GROANING NOISE FROM DOORS

This Service Information Bulletin (Revision 1) replaces SI B51 30 19 dated September 2019.

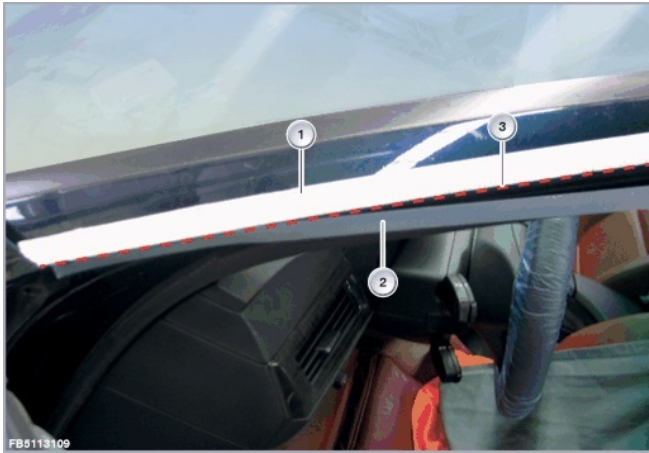
A groaning noise is present from the door frame of any door, most commonly when driving over rough roads or during body flex.

Excessive friction between the window guide and the door opening.

Install anti-friction sliding tape to the door jamb area.

2. Clean the upper door jamb in the area shown (on the body) using silicone remover concentrate 83 12 5 A16 119 of the affected door.

3. Using masking tape (1), mark the area of the body just above the door line (3) as shown to the left.

4. Bond clear sliding tape (2) PN 83 19 9 407 798 to the upper door jamb (on the body) in the area corresponding to the door-mounted seal, just below the area masked off in step 3.
